# **Beaches Link and Gore Hill Freeway Connection**

9 – Addendum – Treatment and loadout of dredged and excavated material not suitable for offshore disposal

## **9 Addendum – Treatment and loadout of dredged and excavated material not suitable for offshore disposal**

**Figure 9-3 Middle Harbour Crossing – Construction noise contour – Standard hours – Prepare foundations (MHC\_08)**

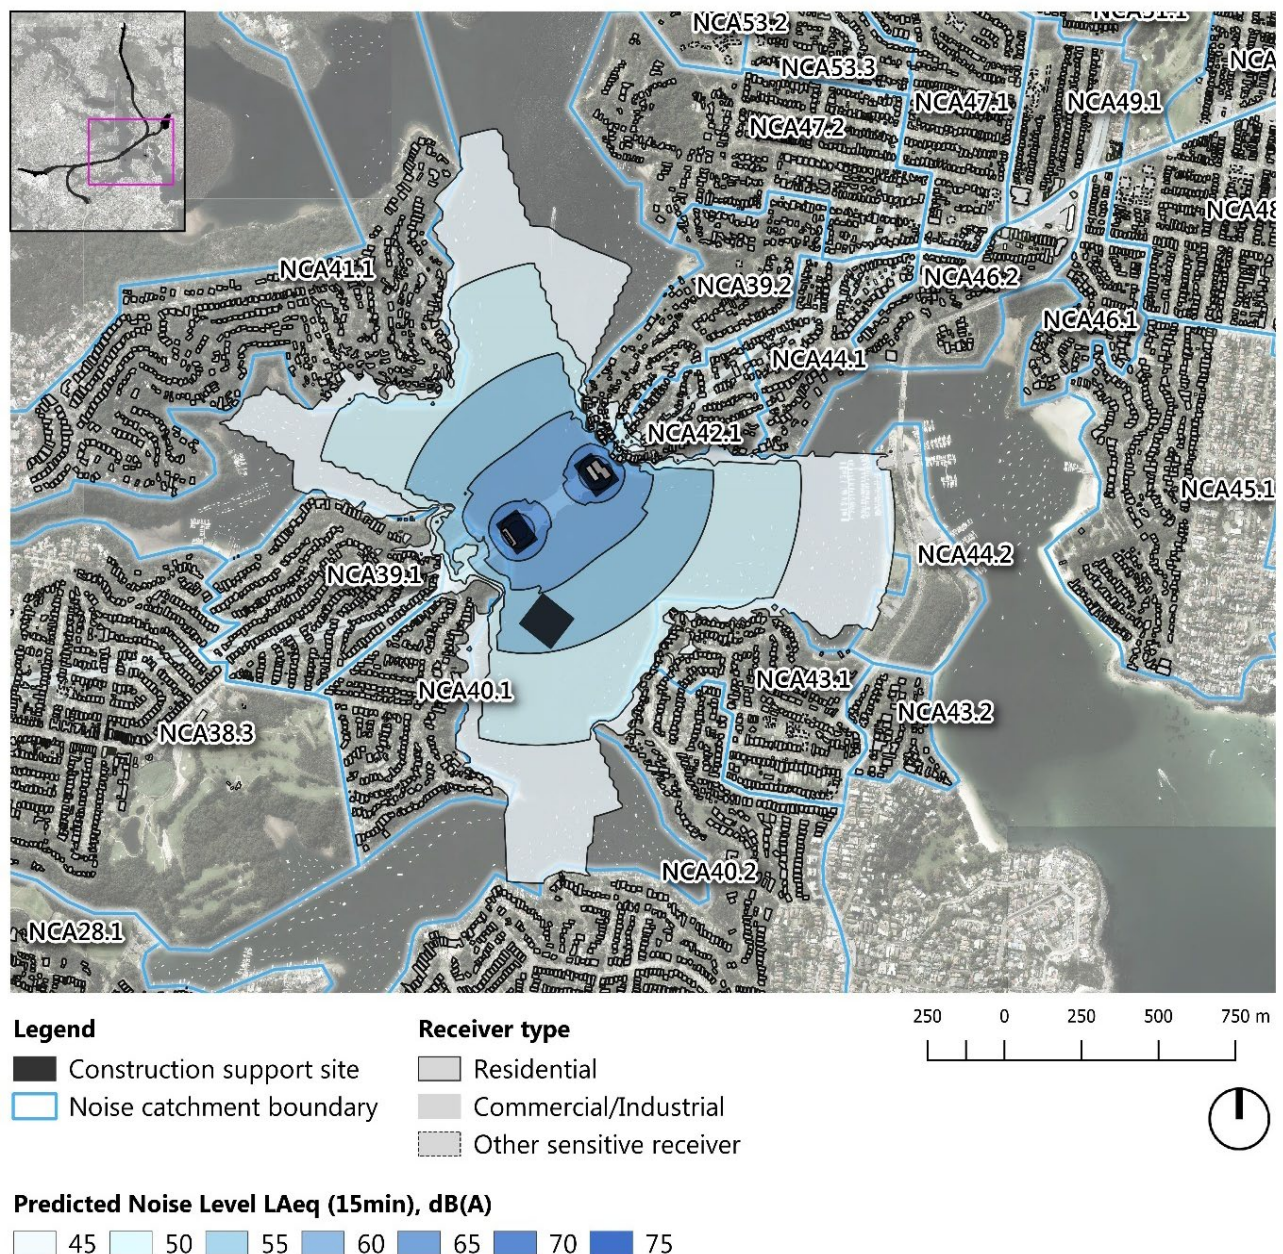
As a result of the revised methodology to now carry out treatment of material within Middle Harbour as part of the dredging and excavation process, minor adjustments are required to the “Prepare foundations” dredging of a trench for the immersed tube tunnels noise assessment scenario, which is reference MHC\_08 in Section 5.7 of Appendix G (Technical working paper: Noise and vibration). This assessment is an update to the assessment presented in Section 5.7 of Appendix G (Technical working paper: Noise and vibration) for the Middle Harbour crossing. The following updates should be read in conjunction with Section 5.7 of Appendix G (Technical working paper: Noise and vibration).

The predicted noise contour for the preparation of foundations (MHC\_08) updating the contour presented in Annexure H.1 of the Appendix G (Technical working paper: Noise and vibration), is presented below in Figure 9-3.

The number of residential receivers predicted to exceed the noise management levels during the prepare foundations (MHC\_08) stage are summarised in Table 9-6 (updating Table 5-110 of the Appendix G (Technical working paper: Noise and vibration)). Predicted noise levels are intended to be conservative and represent reasonable worst case impacts during the project.

There is an increase in the number of potentially noise affected (ie greater than the noise management level) residential receivers during these works, however these receivers remain either potentially impacted by construction noise levels that may be either moderately intrusive (11 to 20 dB(A) above the noise management level) or clearly audible (10 dB(A) or less above the noise management level). Due to the short term nature of the activity over a four week period, there are no proposed changes to the recommended environmental management measures. Any potential construction noise impacts would be managed through the implementation of the construction noise and vibration environmental management measures CNV1 in Appendix C of the preferred infrastructure report.

**Figure 9-4 Predicted maximum ground level odour concentration (OU) near Northbridge in Middle Harbour**

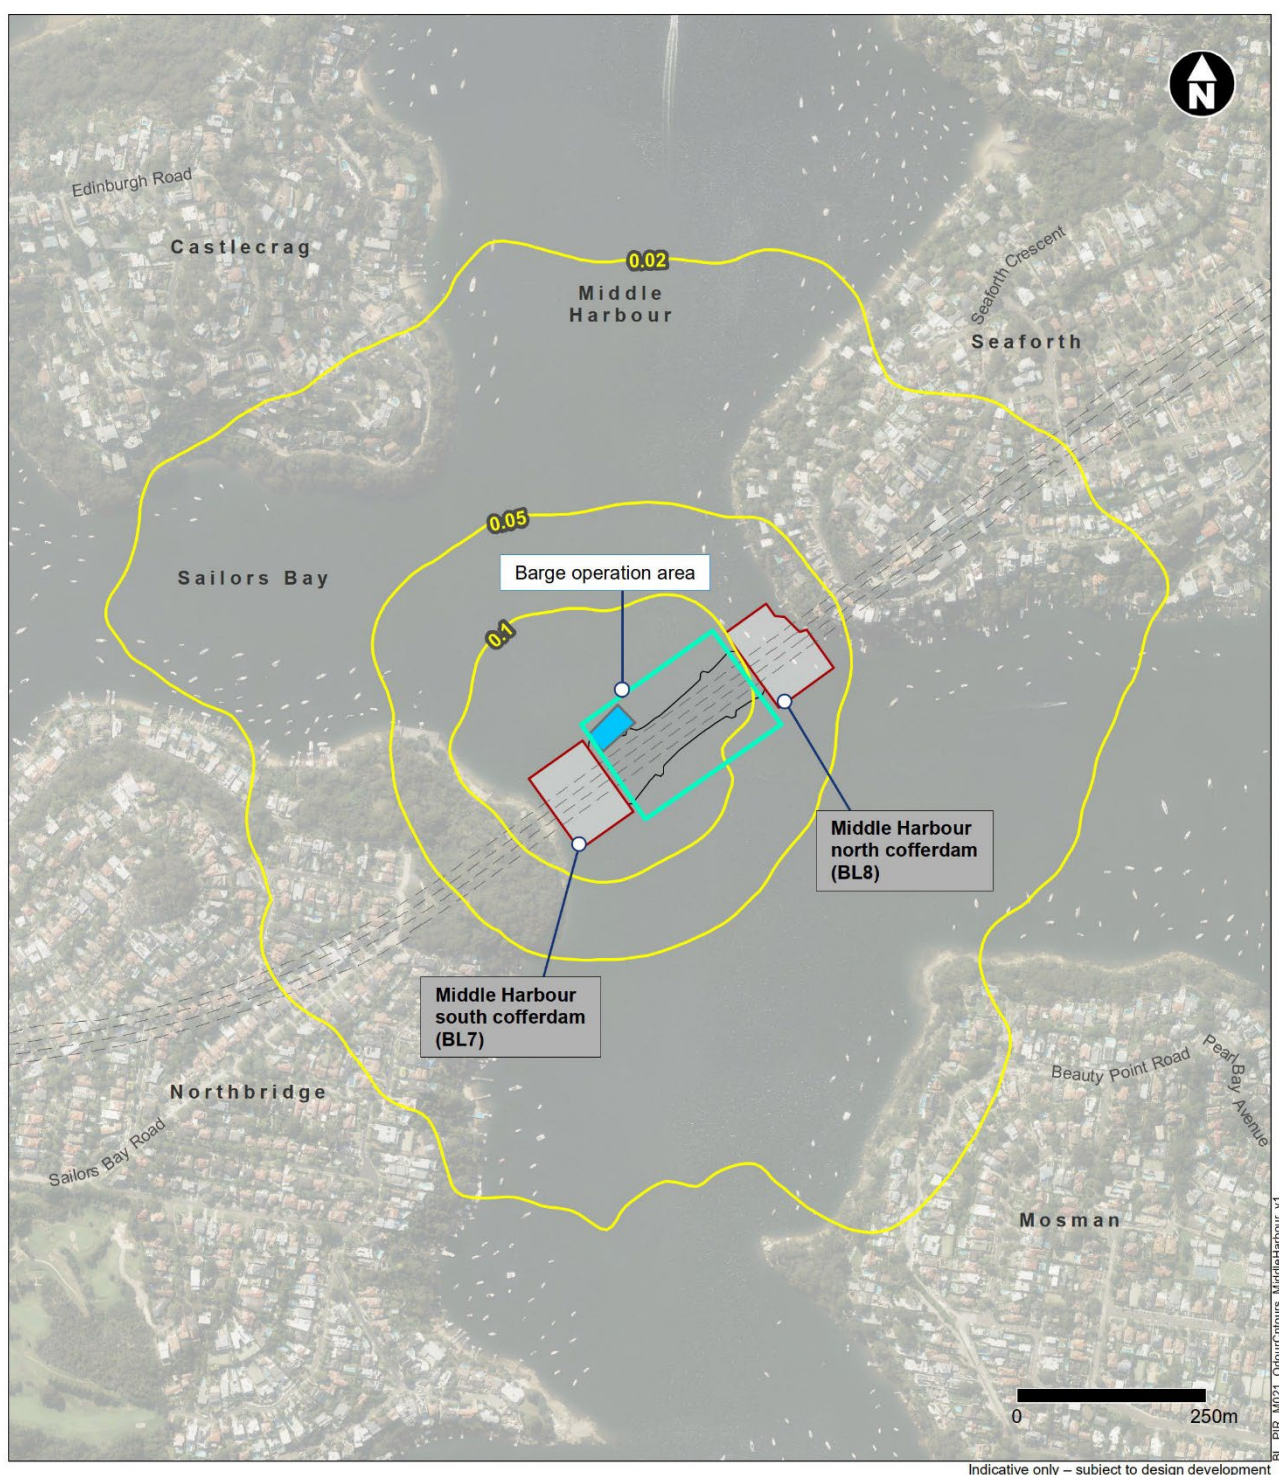
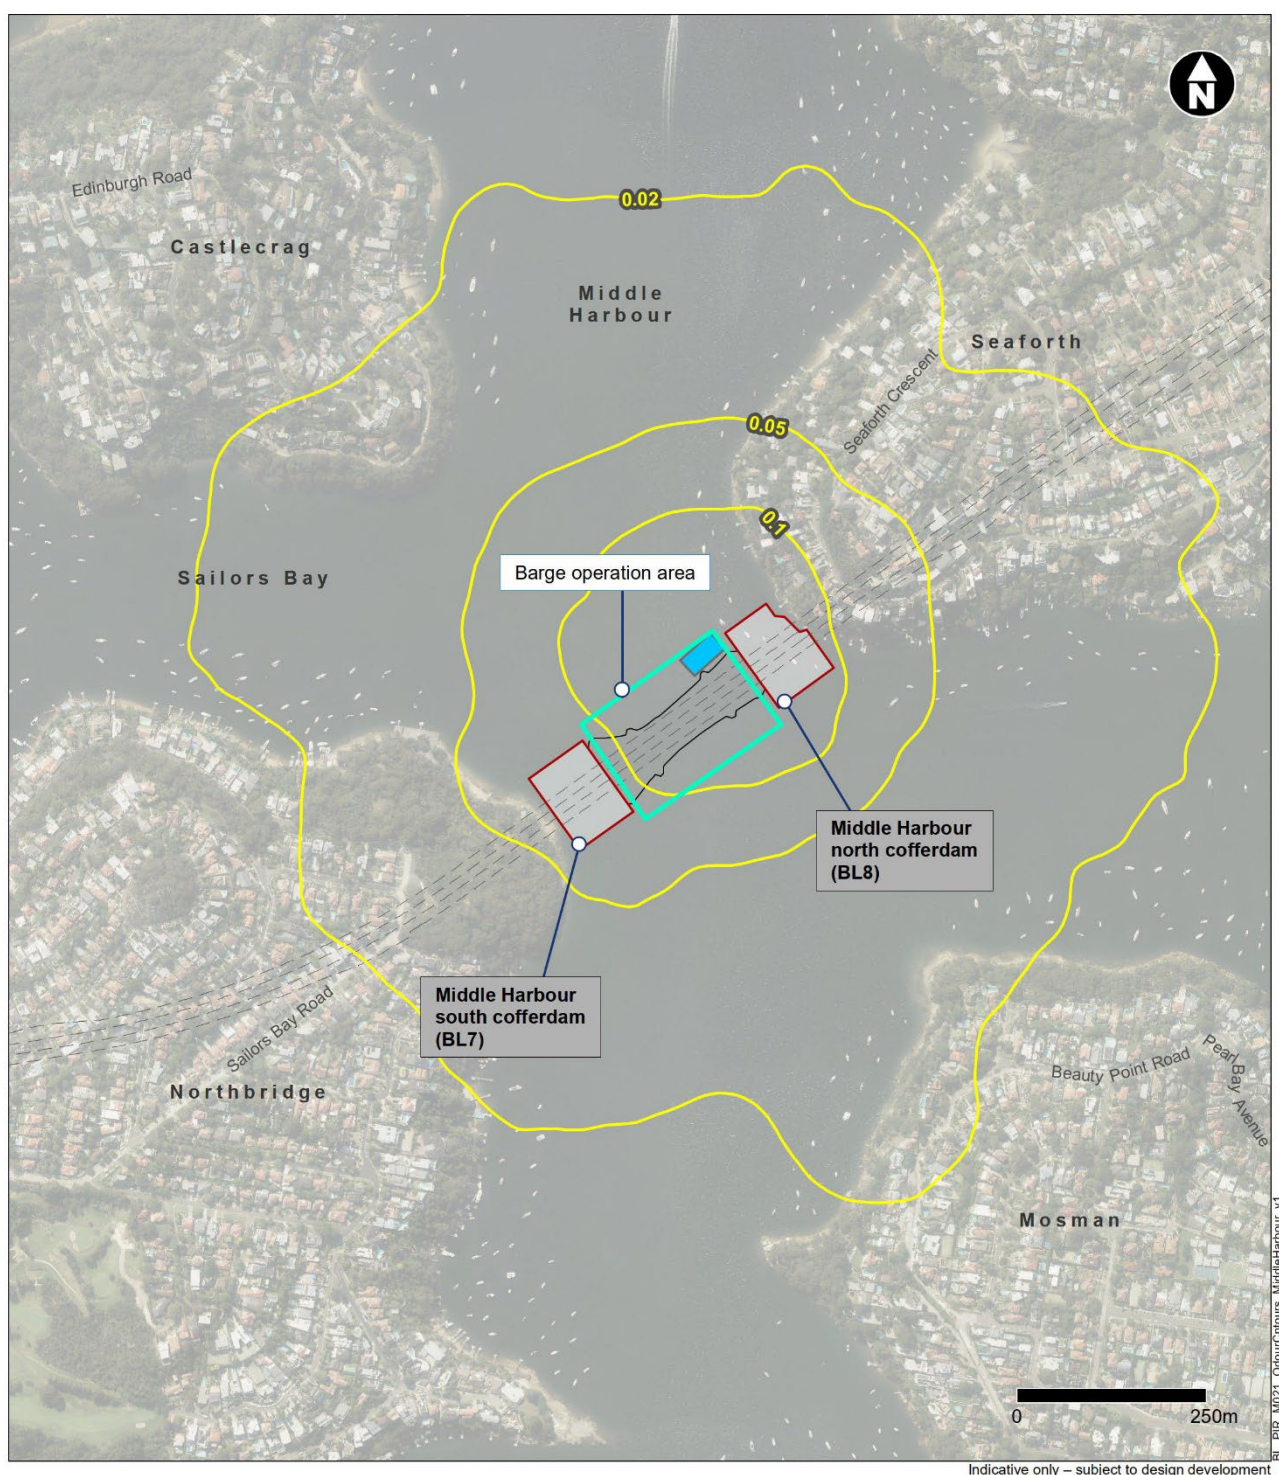
Figure 9-4 and Figure 9-5 present the predicted maximum ground level odour concentration within Middle Harbour near Northbridge and Seaforth, respectively. This assessment has considered the maximum odour concentration due to the short term nature of the operation (expected to be only four weeks in duration). The results presented below indicate that the maximum predicted odour concentrations are likely to remain below the theoretical level of detection (1 OU) and as such likely to be undetectable away from the source, and not at any sensitive receivers such as residential properties or Clive Park.
